March 19, 2004

Refer to: HSA-10/B-125

In your recent letter to Associate Administrator A. George Ostensen, you requested Federal Highway Administration (FHWA) acceptance of a water-filled plastic barrier called the Model SB-1-TL. To support your request, you also sent a copy of the Texas Transportation Institute's (TTI) February 2004 test report entitled "Testing and Evaluation of Safety Barriers, Inc. Water-Filled Barriers" and a digitized video showing the crash test that was conducted.

Patent Applied For		Model SB-1	
See sheet 1 for notes		Safety Barriers Inc. 10440 Lexington Drive Knoxville, TN 37933	
RGM: 6/27/03	0	Profile	5
UNITS	8

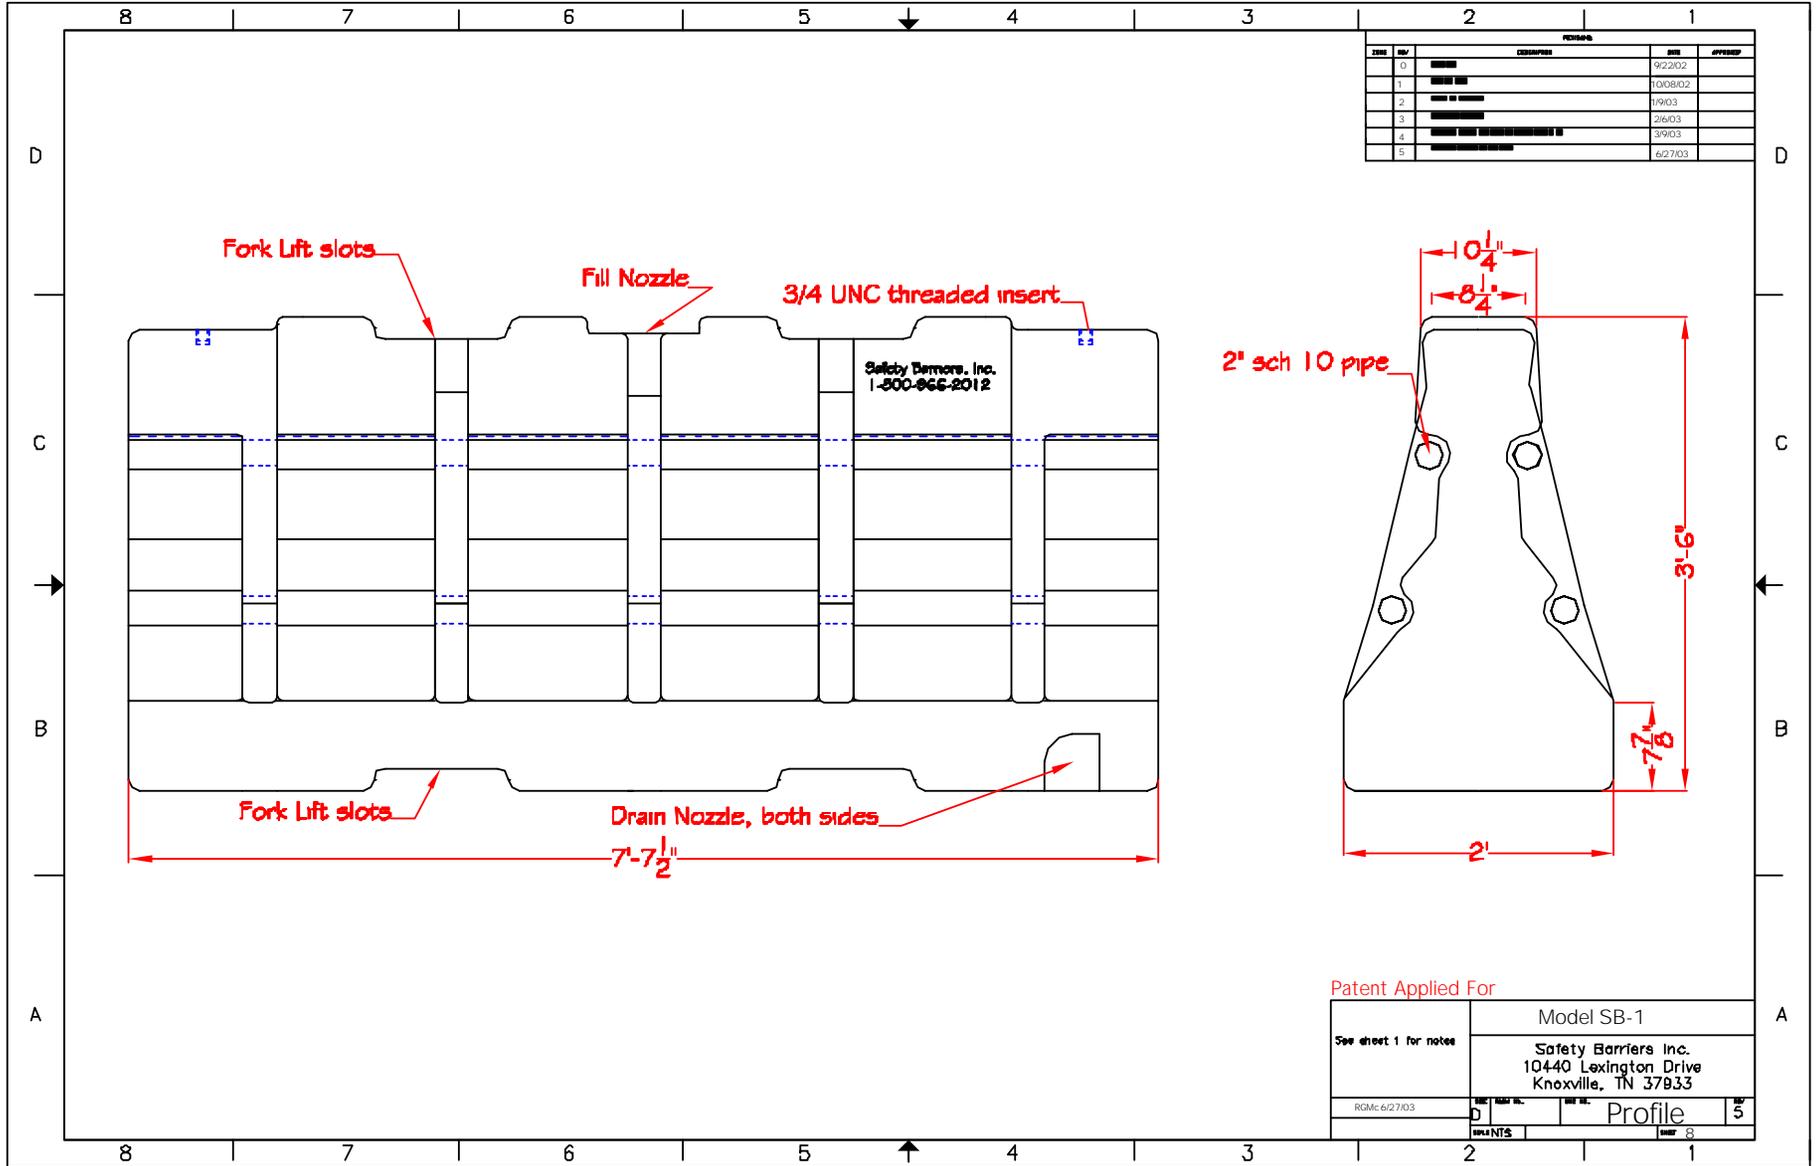
Each of your barrier segments is made from 0.25-inch thick recyclable, virgin, linear low-density polyethylene (LDPE) with UV stabilizers and anti-oxidants, and is ballasted with water. Empty modules weigh approximately 164 pounds with the aluminum pipes in place and filled units are approximately 1840 pounds in weight. The base width of each segment is 2 feet, the vertical height from the ground is approximately 8 inches and the sides of the modules then taper inwards to a top width of 8.25 inches. Total height is 42 inches and, when the barrier is assembled, each segment is effectively 84-inches long. Two schedule 10 2-inch diameter aluminum pipes are cast into each side of each segment and four 5/8-inch diameter 6x25 steel cables are threaded through these pipes to connect all segments together to form the barrier. Special foam-filled end pieces and steel anchor plates at each end of an installation are used to terminate the cables and to remove slack from them. These details are shown in Enclosure 1.

Figure 8. Summary of results for NCHRP Report 350 test 3-11 on Safety Barriers, Inc., water-filled barriers.

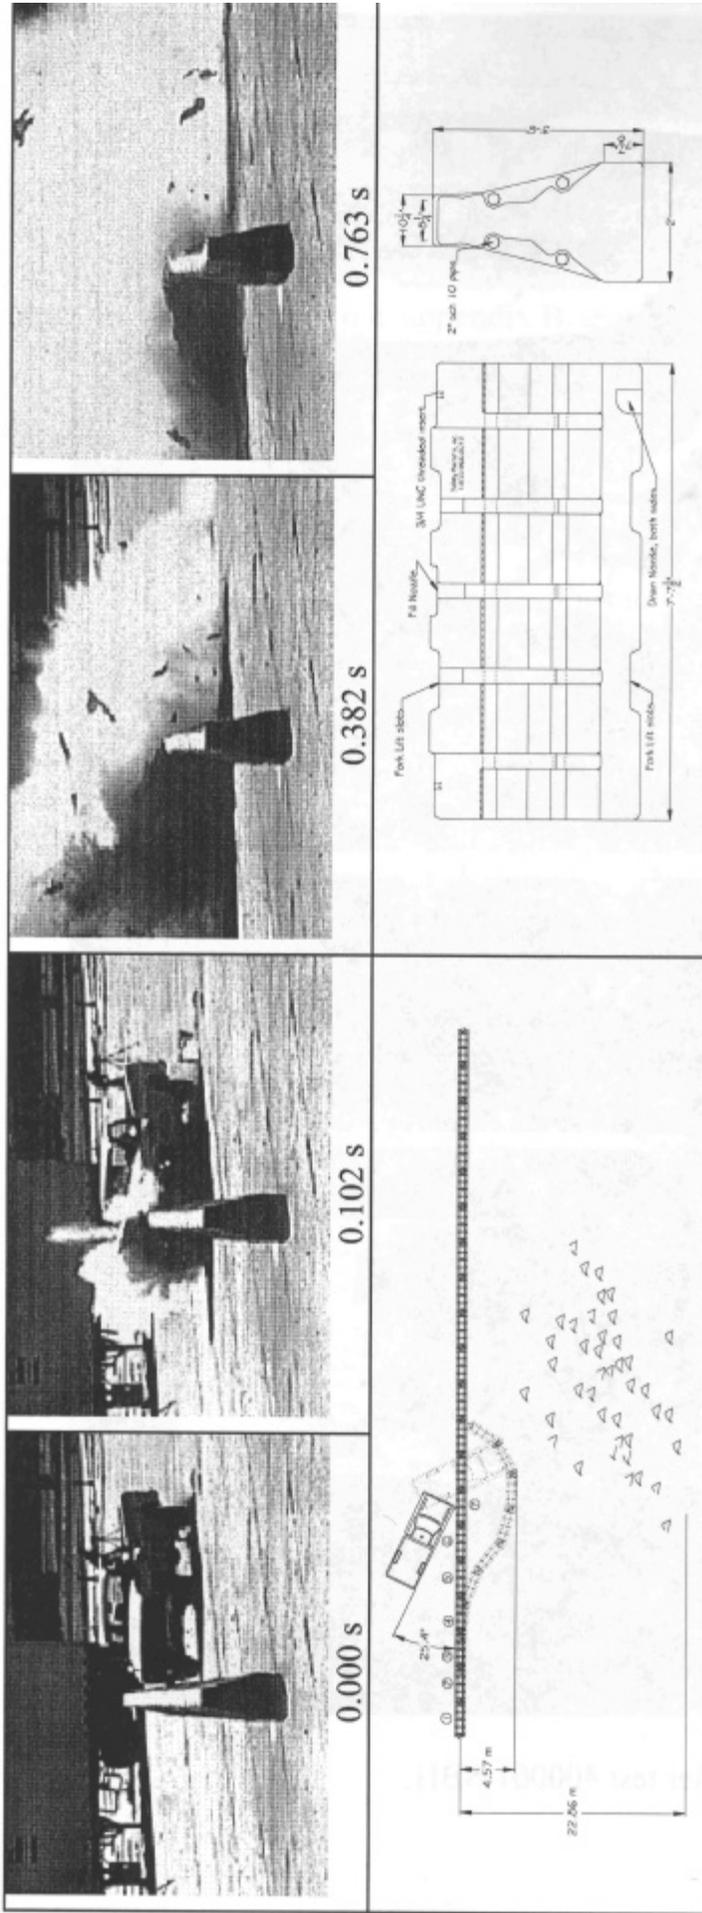
The test installation consisted of 20 individual segments of SB-1-TL modules and two end assemblies for a total installation length of approximately 140 feet. The barrier was impacted 4 feet upstream of the joint between segments 7 and 8, or approximately 45 feet from the beginning of the installation. The pickup truck, impacting at 99.4 km/h and 25.4 degrees, was captured by the barrier, which deflected 15.7 feet. If the barrier were struck nearer to either end of the test installation, the deflection likely would have been even greater. Modules in the immediate impact area shattered, spreading pieces of plastic over a wide area behind the impact zone. Enclosure 2 is the test summary sheet from the TTI test report.

Although the truck was not redirected as is normally seen with a permanent traffic barrier, it was contained by the SB-1-TL modules. Other water-filled barriers have produced similar post-impact results. Section 5.2 of NCHRP Report 350 states that "a primary concern for (temporary longitudinal barriers) ... is the deflection they undergo during a vehicular impact. Because the amount a given installation can deflect without adverse consequences depends on site conditions... it is important to accurately measure and report barrier displacement that occurs during the test so that a user agency can make an objective assessment of the appropriateness of the barrier for its intended application." Thus, as long as potential users are aware that the SB-1-

TL barrier can deflect up to 16 feet in a high-speed, high angle crash and conclude that this displacement will not endanger either motorists or workers behind the barrier, it can be an appropriate choice for use at a specific worksite. The second issue noted in the TTI test report was that of debris scatter. Modules in the immediate impact area shattered, and pieces of plastic were scattered over an area of approximately 100 x 100 feet behind the barrier. While this was an unexpected and generally undesirable occurrence, the debris consisted mostly of relatively small pieces of plastic. Section 5.3 of Report 350 addresses this issue as follows: "Fragments and debris from an impact with a traffic control device in a construction zone may or may not pose a hazard to workers in the zone, depending on their location relative to the device and the impact conditions. Consequently, it is not practical to establish absolute limits on test article trajectory, debris scatter, or barrier displacement. Rather, it is important to accurately record and report (these data) so that a user agency can make an objective assessment of the appropriateness of the safety feature for the intended application." Again then, it is of utmost importance that potential users of the SB-1-TL barrier be aware of its crash characteristics to avoid using it in an unsafe setting.

Based on the above analysis, I agree that the SB-1-TL Barrier, as tested, may be considered a test level 3 (TL-3) temporary barrier. However, its use must be limited to sites where the deflection and debris scatter noted above and in the TTI test report are known and acceptable to the using agency and will not pose an obvious danger to motorists or workers, nor give either group a false sense of security. You may also wish to consider anchoring the ends of the barrier to reduce its dynamic deflection and using a different plastic formulation to eliminate the shattering and subsequent debris scatter seen in the test. These modifications would warrant an additional test to verify their affect on barrier performance.
